**FEDERAL ENERGY REGULATORY COMMISSION
ATLANTA REGIONAL OFFICE
Parkridge 85 North Building
3125 Presidential Parkway - Suite 300
Atlanta, Georgia 30340
(770) 452-3800**

**Operation Inspection Report
for
Nuclear Regulatory Commission
Inspected by
F E R C
Atlanta Regional Office**

Dam (name) Safe Shutdown Impoundment Dam

NRC Licensed Project Comanche Peak Steam Electric Station

Photograph 3 Area located on the left end of the SSID crest that ponds rainfall runoff from the left abutment. Note the vegetation.

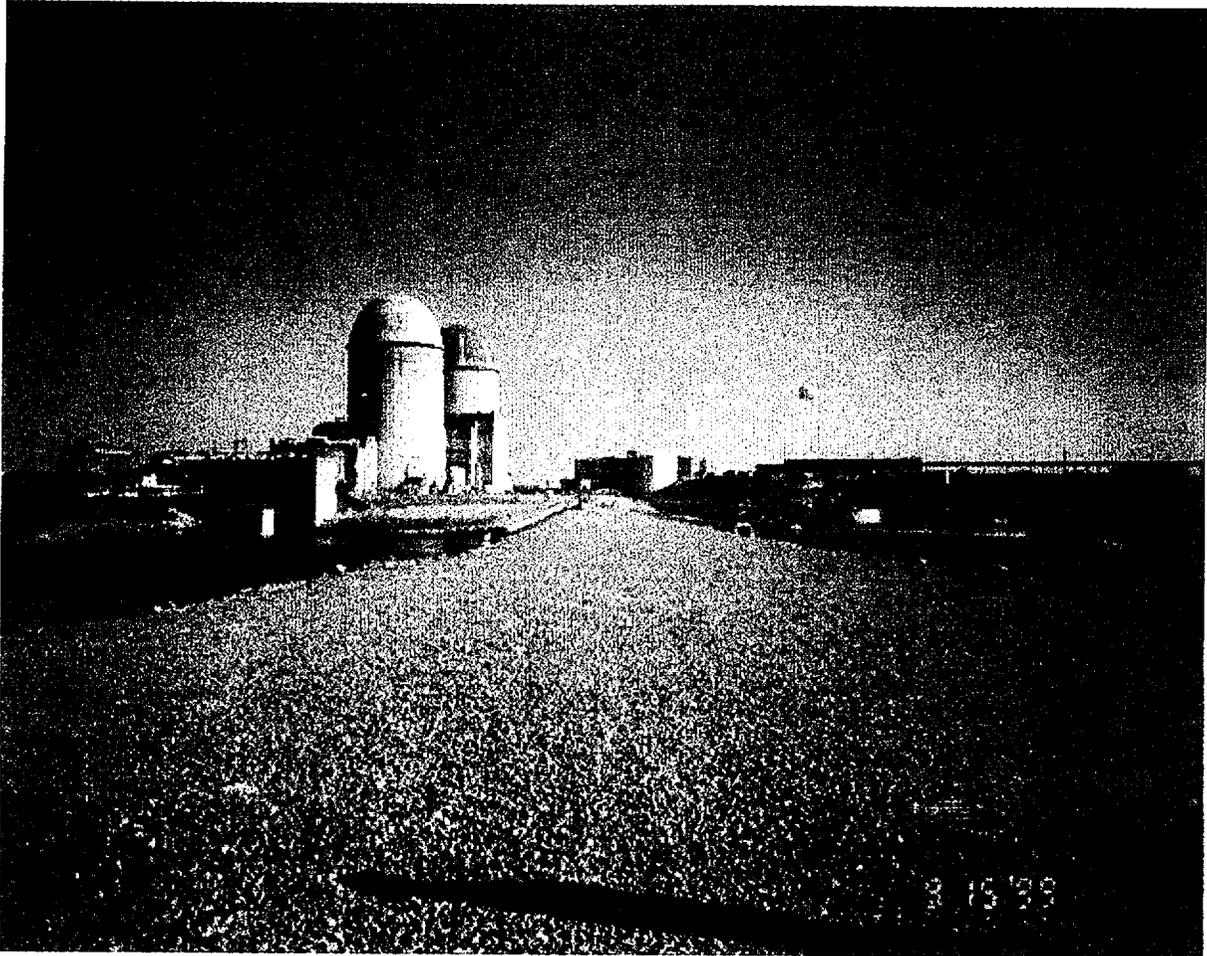
1. Safe Shutdown Impoundment Dam. The dam crest did not display any settlement, instability, or significant erosion. The crest gravel road did not exhibit any significant ruts or problem areas from vehicular traffic (Photograph 2). The left (north) end of the crest had an area that indicated the ponding of rainfall runoff from the abutment (Photograph 3). At the time of this inspection, the ponding did not appear to pose an immediate danger to the integrity of the dam. However, the licensee representatives were informed that some regrading or modifying of the left abutment might be necessary to redirect rainfall runoff from accessing and ponding on the dam. The alignment of the SSID appeared normal with no deformations observed.

Photograph 7 Typical piezometer located on the SSID crest to monitor the phreatic line.

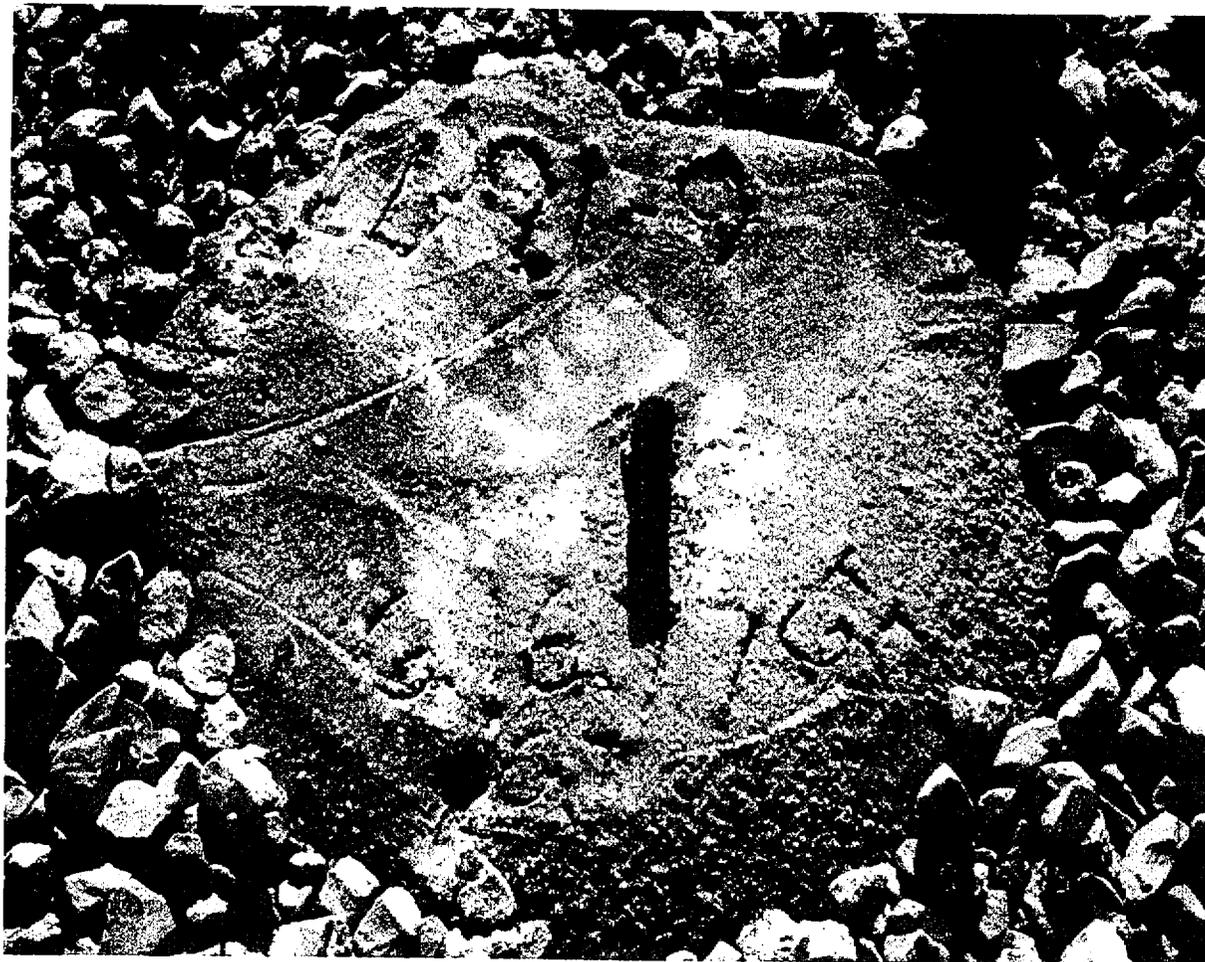
2. Instrumentation. Initially, instrumentation at the SSID included four piezometers and eight settlement monuments (Photographs 7 and 8). Currently, the settlement monuments and three piezometers are monitored.

Piezometric levels P-I-1, P-II-1, and P-II-2 show piezometric levels consistently above the main reservoir and impoundment levels. Historically, the trends of Piezometers P-II-1 and P-II-2 match each other fairly close. P-I-1 shows higher piezometric levels and trends that generally do not match either the other piezometers or the reservoir levels. The accuracy of the three piezometers is suspect, particularly P-I-1. However, the readings do not appear to indicate a threat to the structural integrity of the dam. All the piezometers should be cleaned, tested and evaluated as to their operational status.

Influences from rain infiltration and piezometer design and installation should also be evaluated. The licensee stated that independent consulting firm Freese and Nichols will conduct a study in the year 2000.
